Detailed Site Plan Mill Branch Crossing Inline Retail

DSP-20003-04

STAFF REPORT

SUBJECT: Detailed Site Plan DSP-20003-04
Mill Branch Crossing Inline Retail

Figure 2: Detailed Site Plan

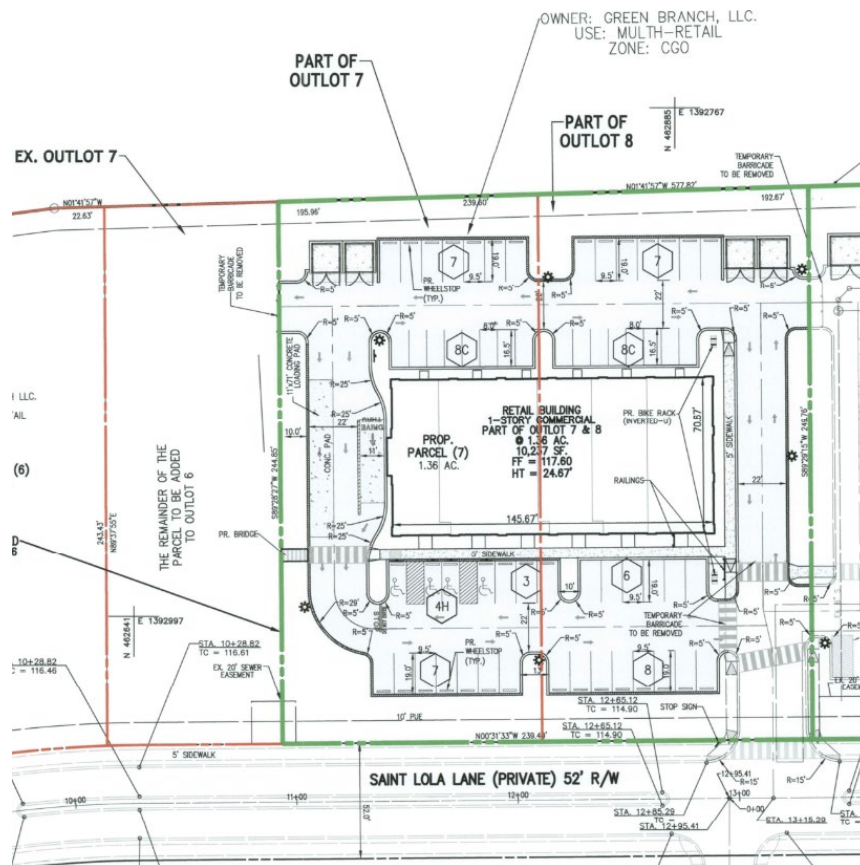
Note: *The loading space size shown on the DSP does not meet the width requirement outlined in Section 27-582(a) of the prior Zoning Ordinance. A condition has been included herein to revise the loading space size to comply with this requirement. The length of the loading space shown is more than double the minimum length required. As such, two loading spaces can fit in the area dedicated to loading on the DSP. A condition has been included herein to revise the DSP to show the required two loading spaces.

This DSP includes four U-shaped bicycle racks, two of which are located near the entrance of the front of the building, and two near the rear entrance, to support a multimodal system of service. The configuration of these bicycle racks, as shown on the DSP, may cause bicycles to stick out into the sidewalk or parking facilities. A condition is included herein to rotate the position of the bicycle racks to avoid these potential conflicts.

Manual), which screens the loading space from Saint Lola Lane. The loading space shown on the DSP is 11 feet wide and 71 feet long. The minimum width for a loading space per Section 27-578 of the prior Zoning Ordinance is 12 feet wide. A condition is included herein to revise the loading space to comply with this requirement.

lighting plans on adjacent properties. The lighting plans do not specifically indicate that the fixtures are full cut off. A condition has been included herein requiring full cut-off fixtures.

1. Prior to certificate approval of the detailed site plan (DSP), the following revisions shall be made, or information should be provided:
 - a. Update the truck turning exhibit to demonstrate the ability of large vehicles to exit the site.

- b. Revise the area shown for the loading space to show two separate loading spaces with minimum dimensions of 12 feet wide and 33 feet long in accordance with Sections 27-578 and 27-582(a).

- c. Rotate the configuration of the bicycle racks to avoid potential conflicts with sidewalks and parking areas.
 - d. Provide additional signage details as required by Section 27-596(c) of the prior Prince George's County Zoning Ordinance, which should specify a unified use of materials and styles that is compatible with the building and other approved signage within Mill Branch Crossing, to be reviewed by the Urban Design Section as designee of the Planning Board.

- e. Provide notes on the lighting details stating lighting fixtures will be full cut-off.
 - f. Indicate the location of any proposed fire department connection (FDC). A hydrant must be provided within 200 feet of any FDC as hose is laid by the fire department; along drive aisles, around corners, around obstacles, etc. as required by Subtitle 4-167 of the Prince George's County Code.
